SUBJECT: Davidson County, Replace Bridge No.416 over Beaverdam
Creek; T.I.P. Number B-4103; Federal Aid Project No.
BRSTP-2550(1); State Project No. 8.2604601

Attached are the modifications to the U.S. Army Corps of Engineers Section 404 Nationwide Permit Numbers 23 & 33 and the N.C. Division of Water Quality Section 401 for the above referenced project. All environmental permits have been received for the construction of this project.

GENERAL PERMIT (REGIONAL AND NATIONWIDE) VERIFICATION

PROJECT REFERENCE NO. B 4103 SHEET NO. 2-B
 RW SHEET NO.
 ROADWAY DESIGN ENGINEER
 HYDRAULICS ENGINEER
Permit Drawing
Sheet 6 of 9
PRELIMINARY PLANS
 DO NOT USE FOR CONSTRUCTION
 rev. 11/27/07

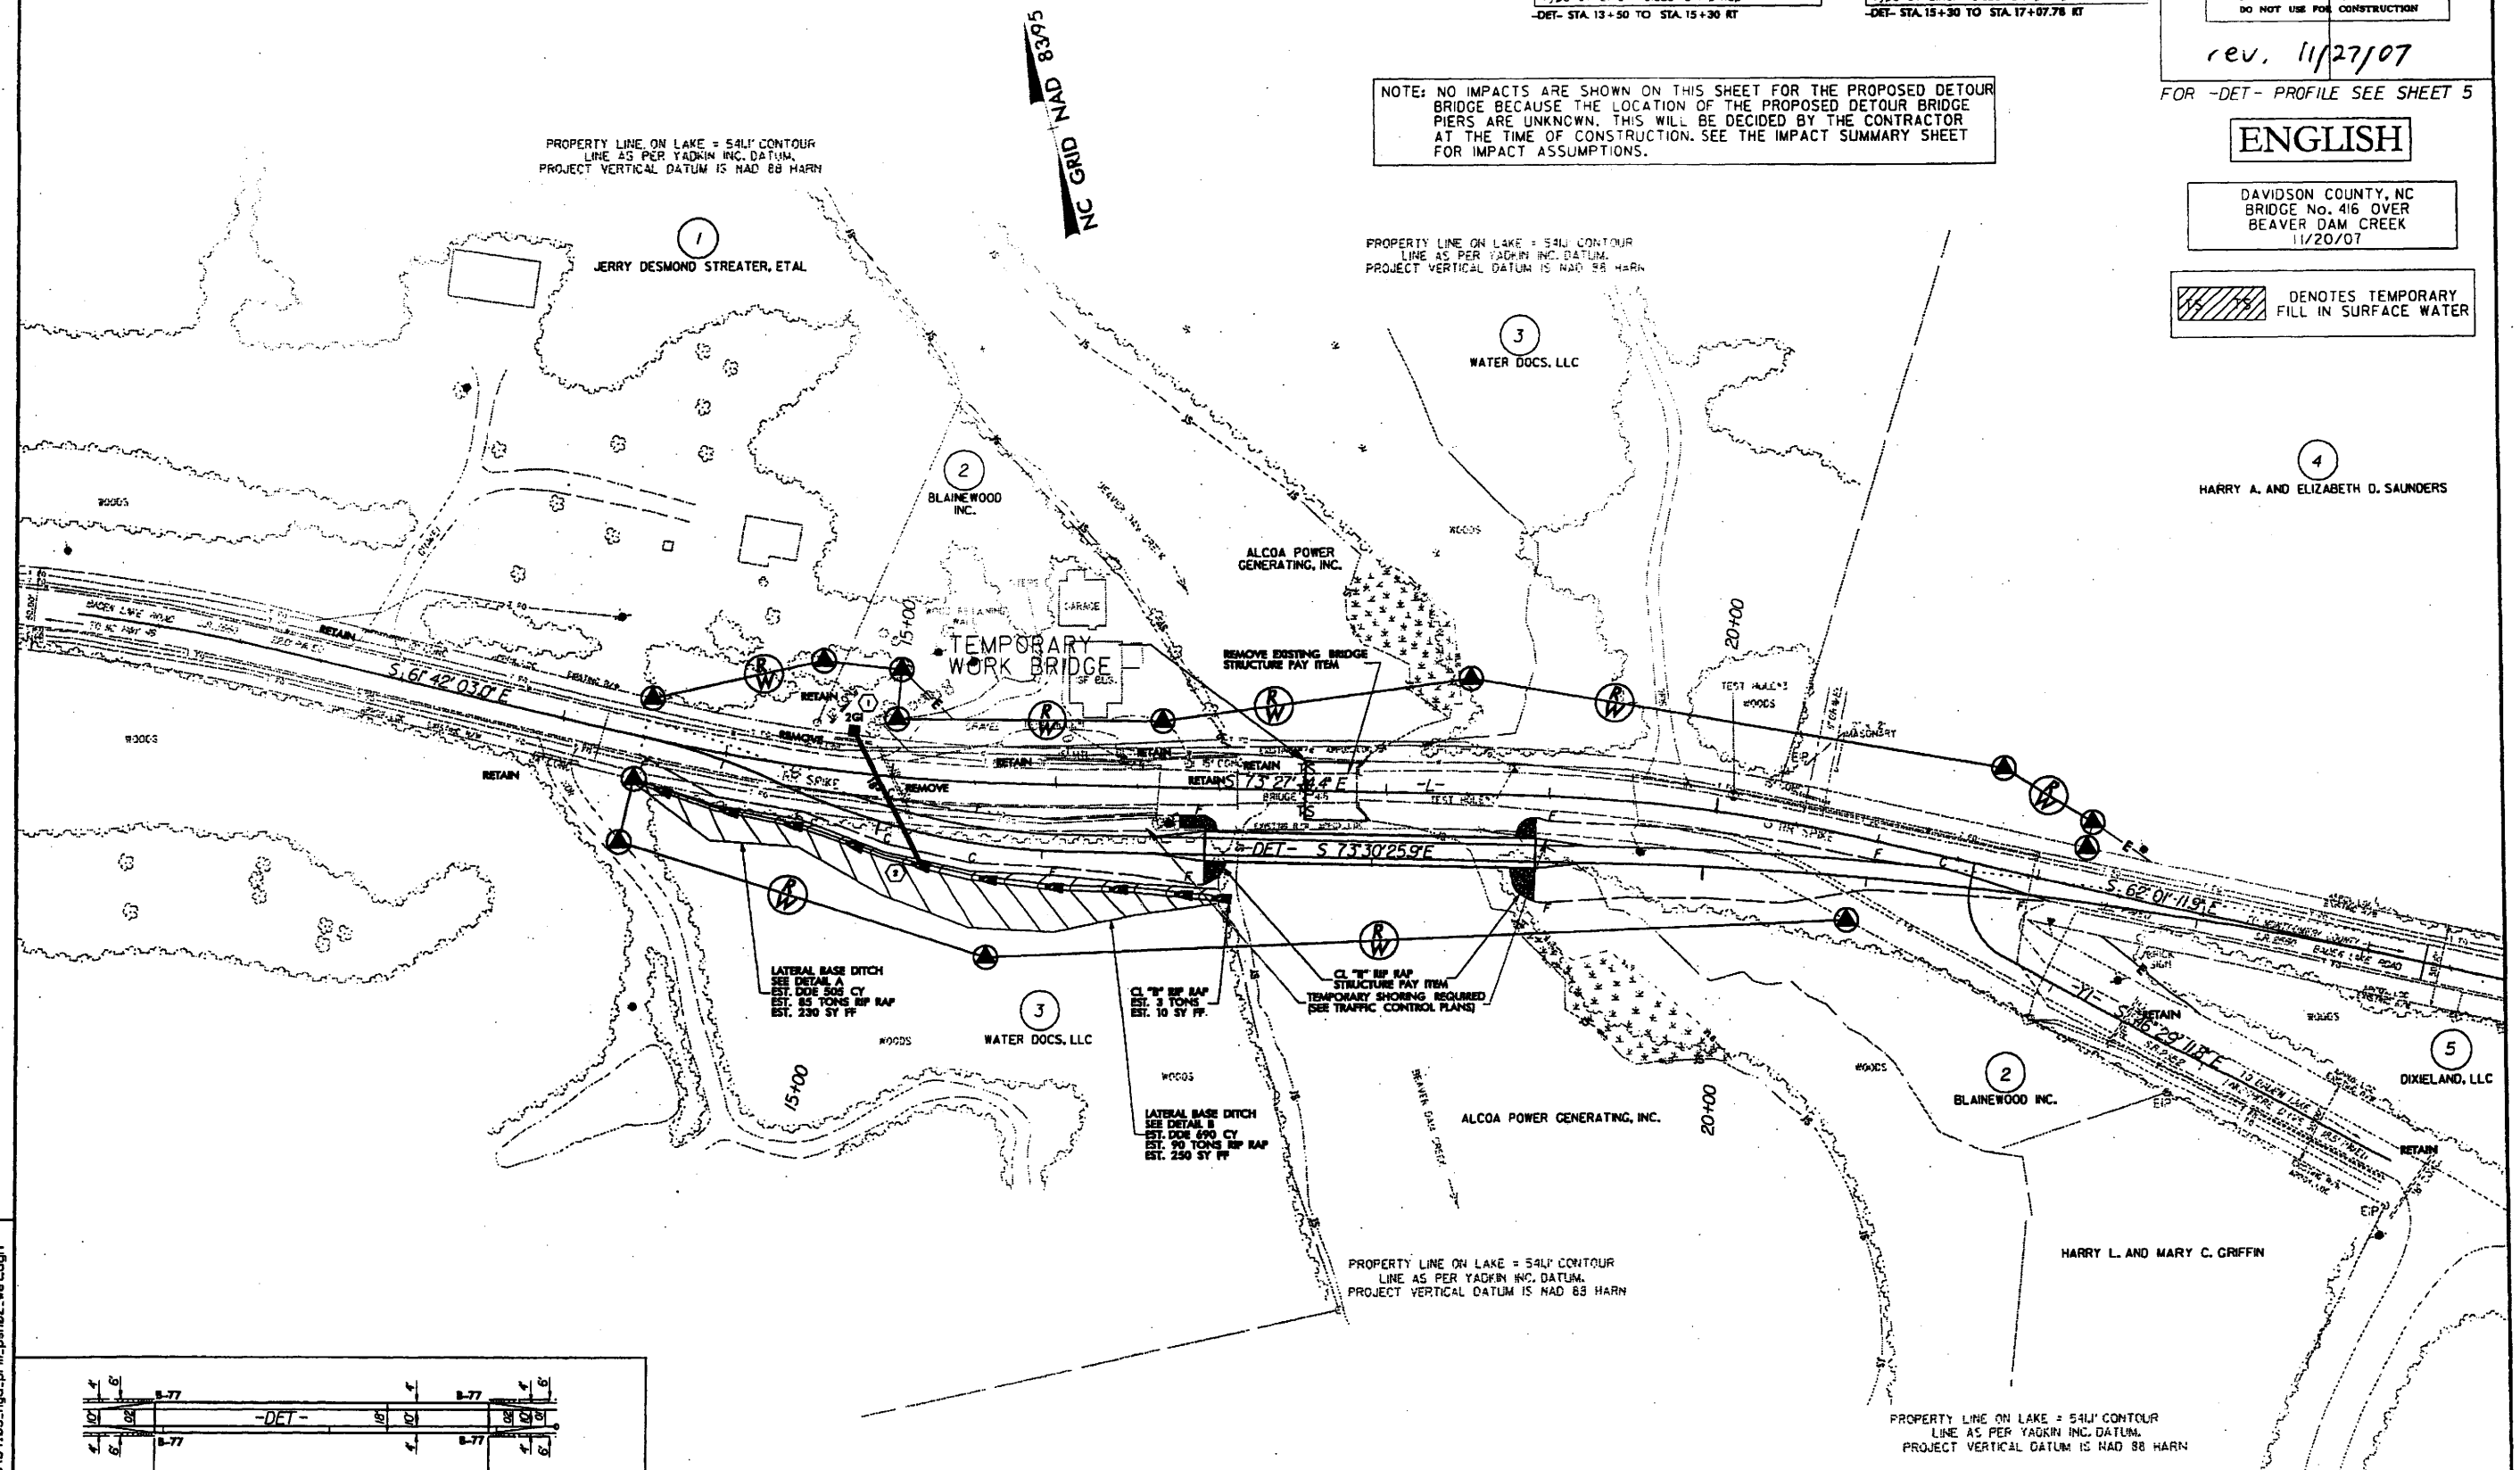
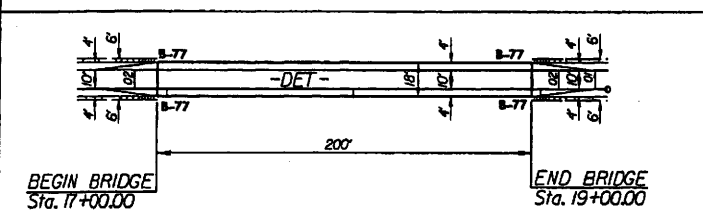
NOTE: NO IMPACTS ARE SHOWN ON THIS SHEET FOR THE PROPOSED DETOUR BRIDGE BECAUSE THE LOCATION OF THE PROPOSED DETOUR BRIDGE PIERS ARE UNKNOWN. THIS WILL BE DECIDED BY THE CONTRACTOR AT THE TIME OF CONSTRUCTION. SEE THE IMPACT SUMMARY SHEET FOR IMPACT ASSUMPTIONS.
